**STAFF RECOMMENDATION**  
**3960 Woodlawn Drive**  
**July 18, 2018**

**Application:** New Construction—Infill and Outbuilding  
**District:** Woodlawn West Neighborhood Conservation Zoning Overlay  
**Council District:** 24  
**Map and Parcel Number:** 11604029900  
**Applicant:** Chris Goldbeck, P. Shea Designs  
**Project Lead:** Melissa Baldock, melissa.baldock@nashville.gov

**Description of Project:** Application is construct infill and an outbuilding on vacant lot.

Figure 1. The former lot at 200 Ensworth, seen from Ensworth Avenue.

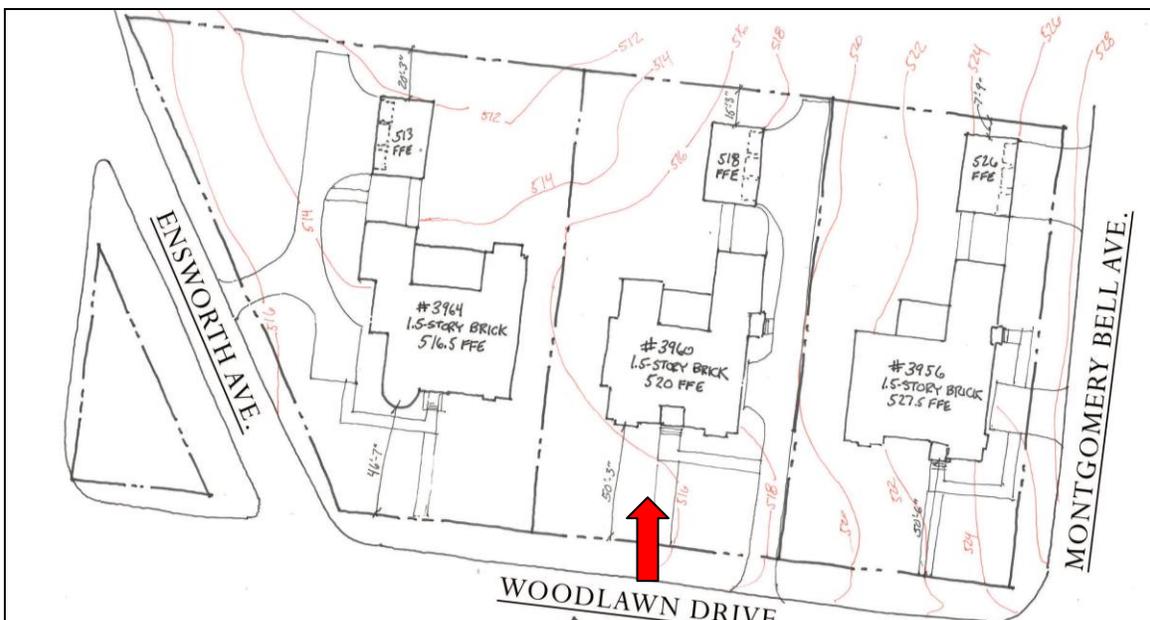
**Background:** 3960 Woodlawn Drive is one of three lots that was formerly part of the lot at 200 Ensworth (Figure 1). The existing house on the lot is non-contributing, and MHZC staff issued an administrative permit to demolish it in June 2018. The existing house sat on three former lots, and the owner of the parcel has reestablished the lot lines to create three separate lots, each facing Woodlawn Drive (Figure 2). This address is located at the corner of Woodlawn Drive and Montgomery Bell Avenue. There are no other houses in the Woodlawn-West Neighborhood Conservation Zoning Overlay that are oriented to Woodlawn Drive. Staff looked to the houses on Kimpalong Avenue and Ensworth Avenue for context.

SITE PLAN  
1:40

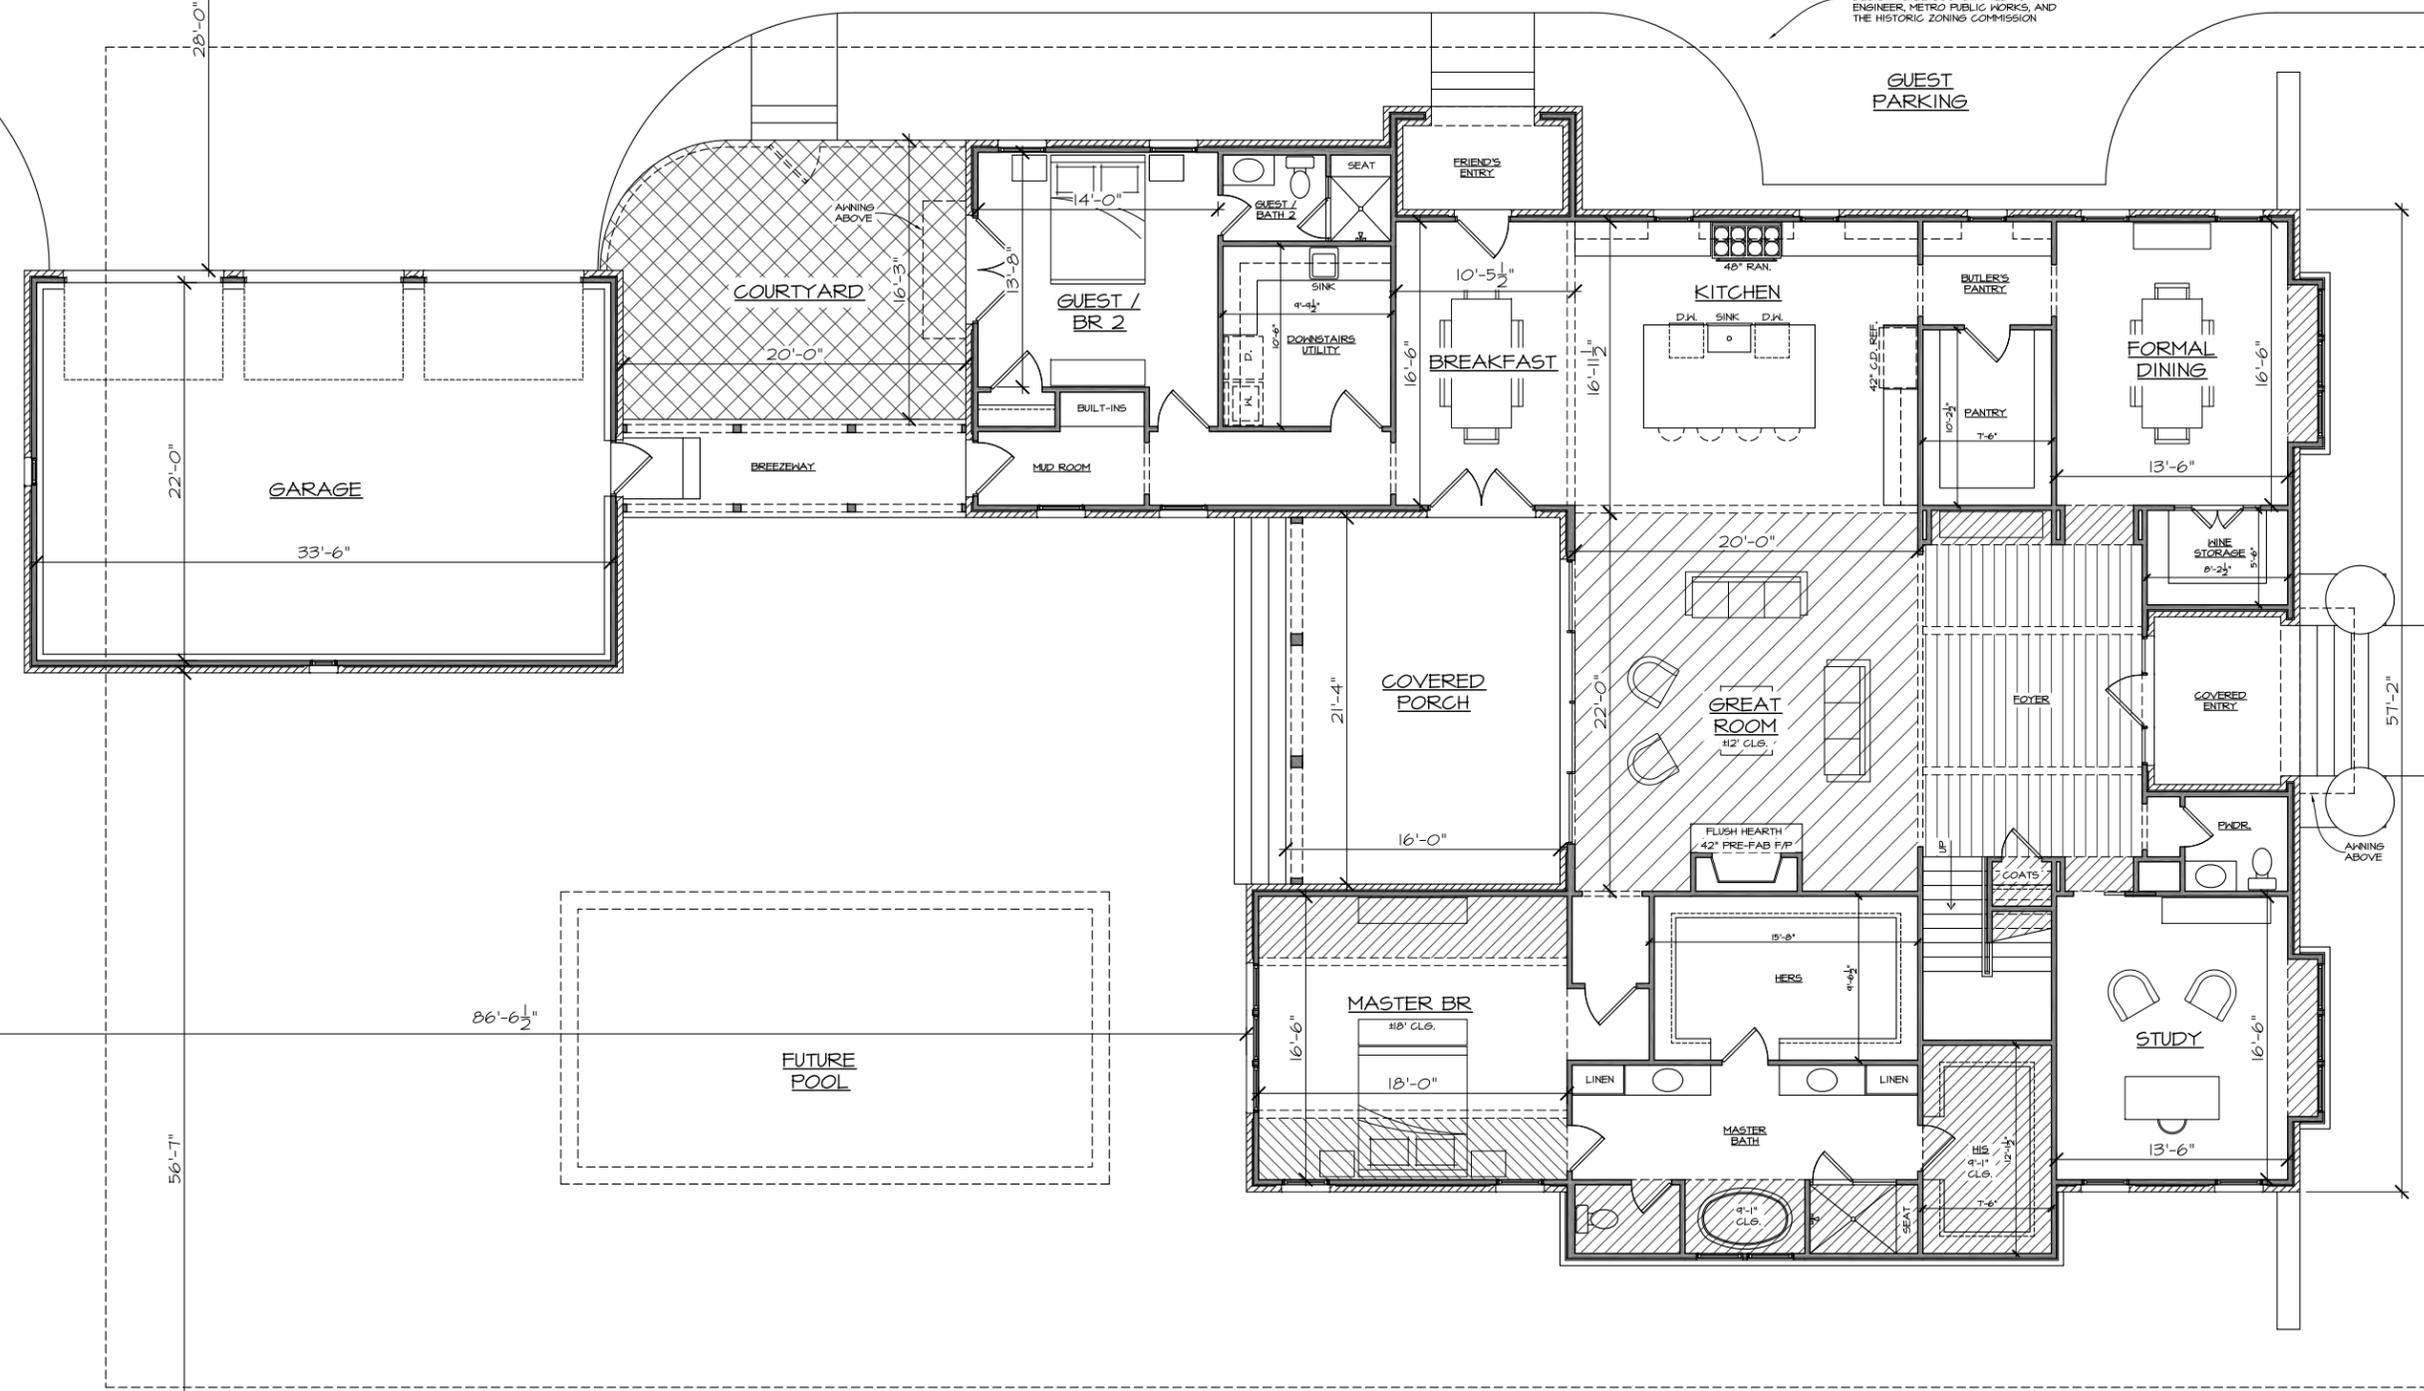
Setback & Rhythm of Spacing: There are no houses within the Woodlawn West Neighborhood Conservation Zoning Overlay that face Woodlawn Drive, and the houses outside of the overlay on the other side of Montgomery Bell Avenue are on deeper lots. There is no established front setback. The applicant is proposing to situate the infill about fifty feet, three inches (50'3") from the front property line, which staff finds to be appropriate. The infill will be approximately eighteen feet (18') from the right side property line and twenty-two feet (22') from the left side property line. It will be approximately seventy feet (70') from the rear property line. These meet the base zoning setbacks and are appropriate for the context. Staff finds that the proposed setbacks and rhythm of spacing meet Section II.B.1.c. of the design guidelines.

Orientation: The house is oriented towards Woodlawn Drive, which is appropriate. Vehicular access to the site will be via new curb cut off of Woodlawn Drive. Staff finds this to be appropriate because the site lacks an alley. There is a small parking area for a guest along the right side of the house. Because of its small size and because there is no street parking on Woodlawn, Ensworth, and Montgomery Bell Avenues, staff finds this parking area to be appropriate. Staff finds that the house’s orientation meets Section II.B.1.f. of the design guidelines.

<b>MINIMUM</b>	<b>PROPOSED</b>
<b>Building located towards rear of lot</b>	n/a	Yes
<b>Space between principal building and DADU/Garage</b>	20’	20’
<b>Rear setback</b>	3’	15’
<b>L side setback**</b>	5’	56’7”
<b>R side setback**</b>	5’	28’
<b>How is the building accessed?</b>	From the alley or existing curb cut	New curb cut

Staff finds that the outbuilding’s site planning and setbacks meet Section II.B.h.2 of the design guidelines.

FRONT ELEVATION  
SCALE: 1/4" = 1'-0"

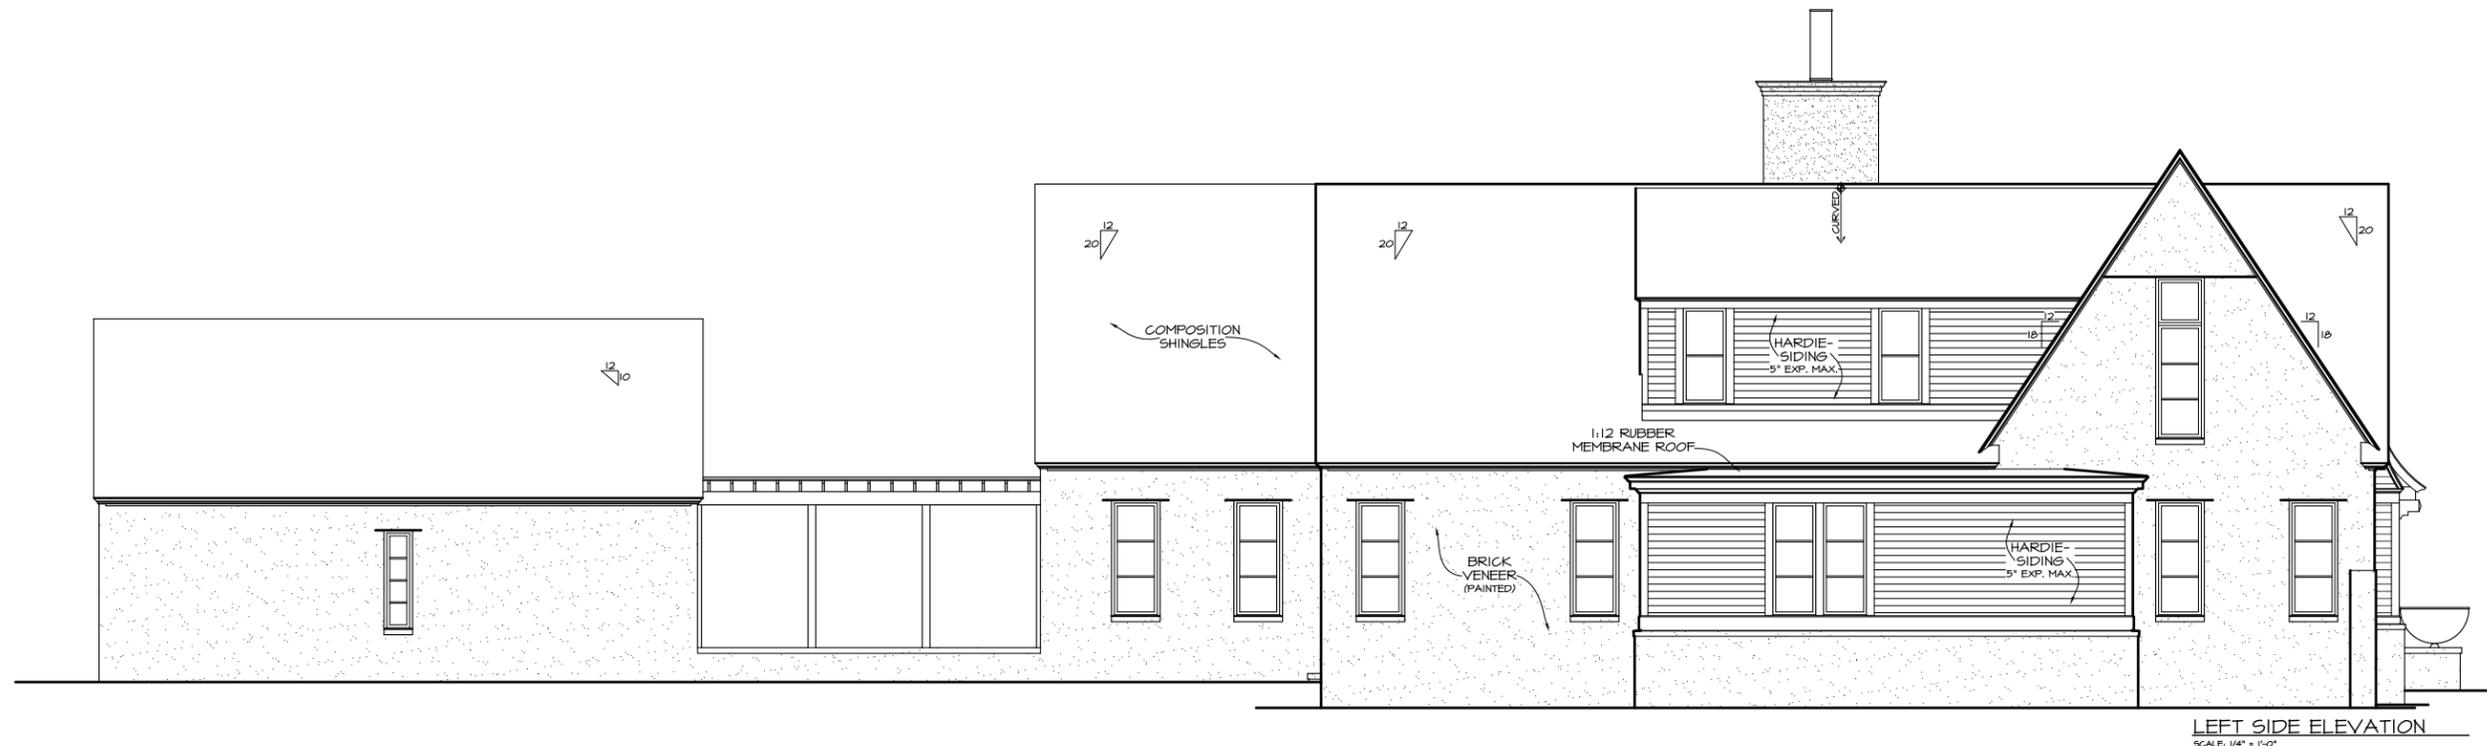
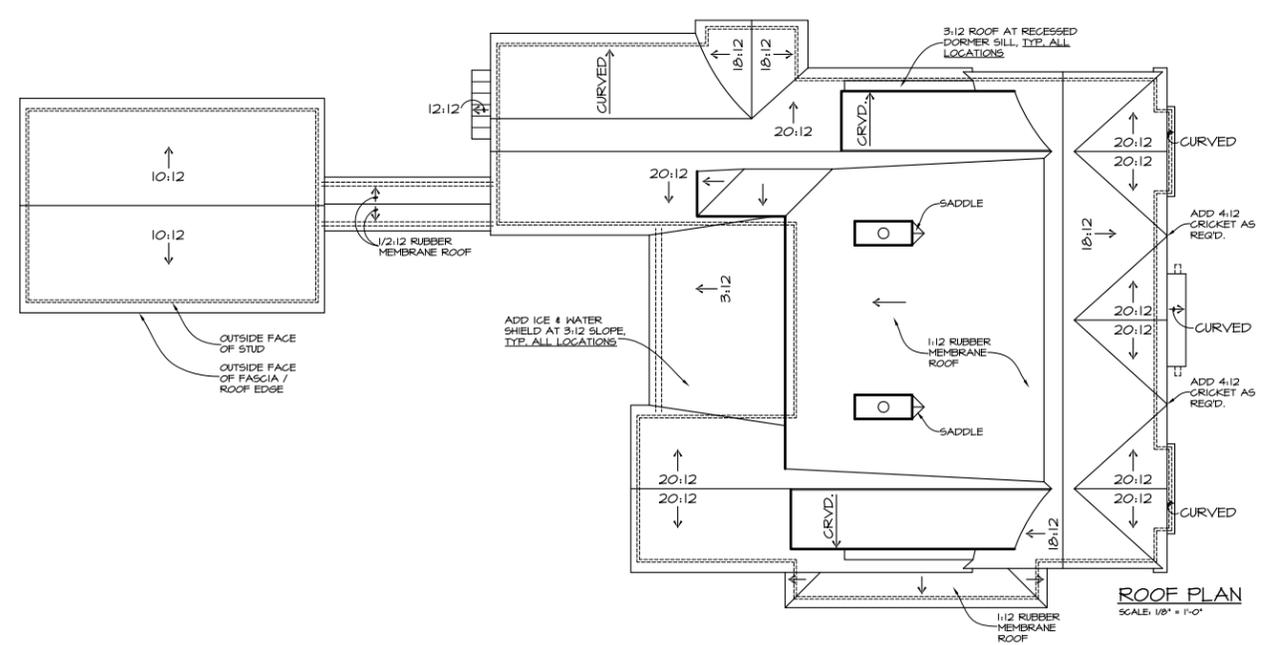
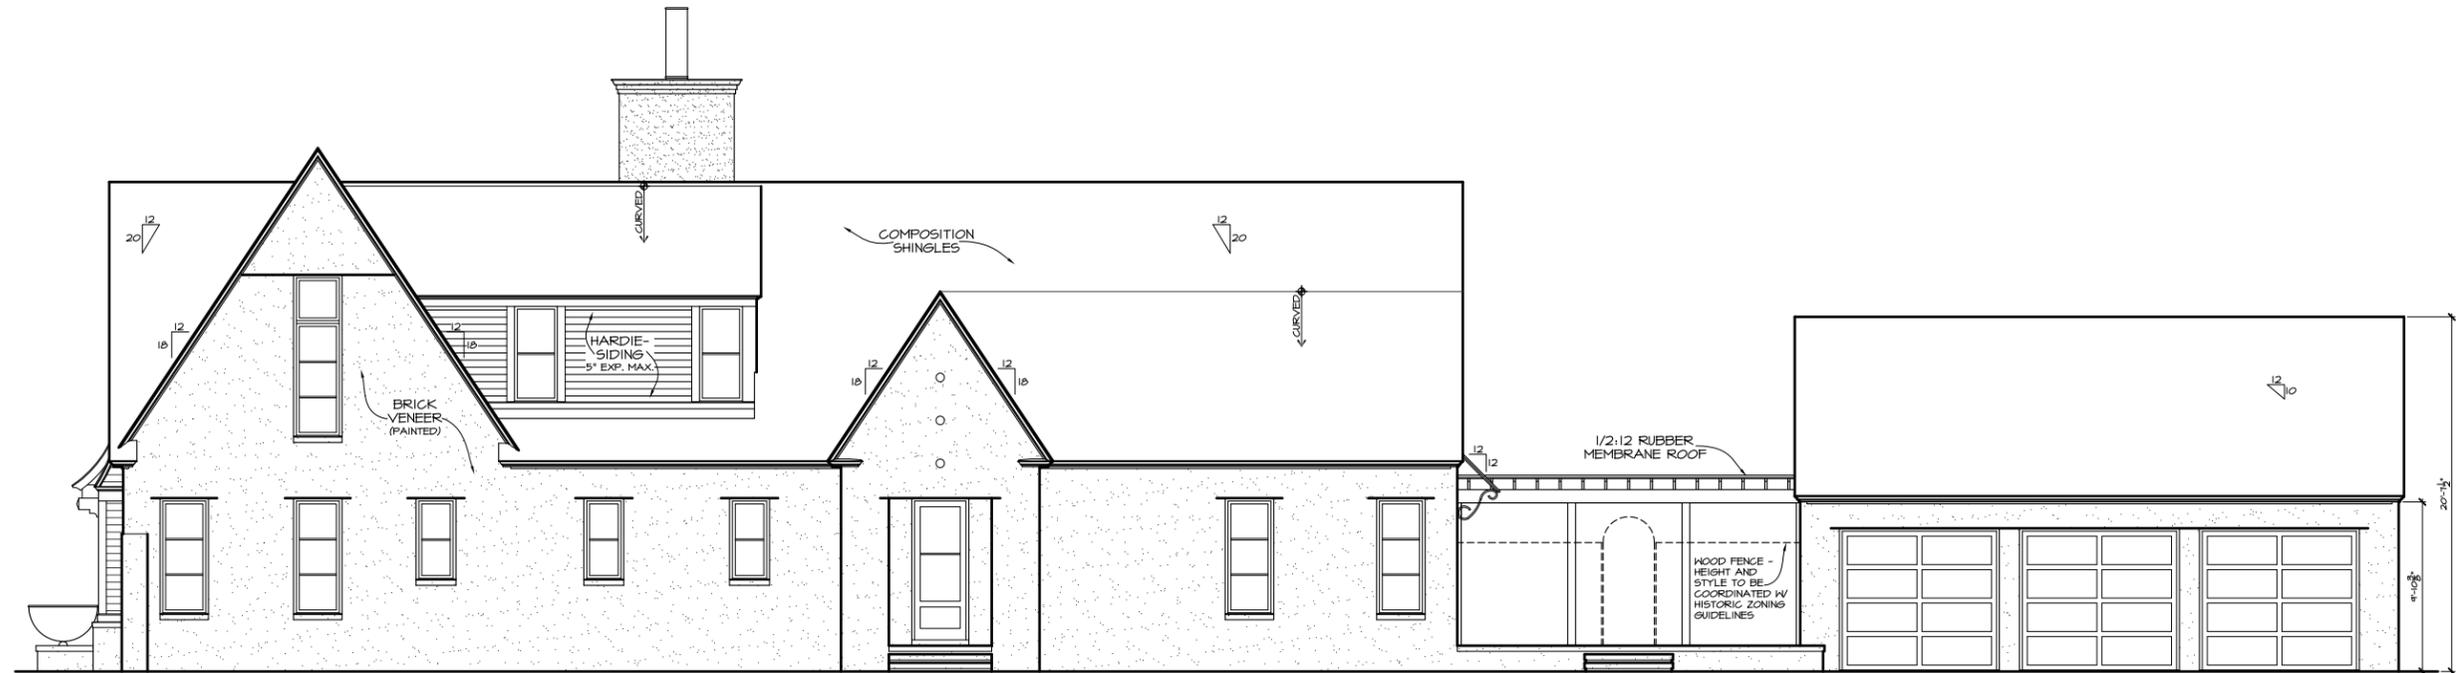
Height & Scale: The proposed infill is one-and-a-half stories in height, which meets the historic context. The historic houses along Kimpalong Avenue are largely one and one-and-a-half stories in height, and the historic houses along Ensworth Avenue are largely two-stories in height. The proposed ridge height of the infill ranges from thirty feet, five inches (30'5") to thirty-two feet, five inches (32' 5") from grade because of the slope of the site. Staff finds this to be appropriate, as the historic houses along Ensworth Avenue range in height from nineteen to thirty-six feet (19'-36'). The eave height ranges from twelve feet to fourteen feet (12'-14') because of the grade.

**Roof form:** The infill’s primary roof form is a cross gable with a slope of 18/12 on the side and 20/12 at the front. The front bays and side dormers have curved shed forms; the dormers are all inset a minimum of two feet (2’), as is required. Staff finds that the

Proportion and Rhythm of Openings: The windows on the proposed infill are all at least twice as tall as they are wide, thereby meeting the historic proportions of openings. There are no large expanses of wall space without a window or door opening. All double and triple window openings have four to six inch (4”-6”) mullions in between them. Staff finds the project’s proportion and rhythm of openings to meet Section II.B.1.g.

1. The finished floor height be consistent with the finished floor heights of the adjacent historic houses, to be verified by MHZC staff in the field;
2. The cedar siding be smooth;
3. The stairs and floor of the front and side stoops be wood or concrete;
4. Staff approve a brick sample, the roof shingle color and texture, and all windows and doors prior to purchase and installation;
5. The HVAC be located behind the house or on either side, beyond the mid-point of the house.
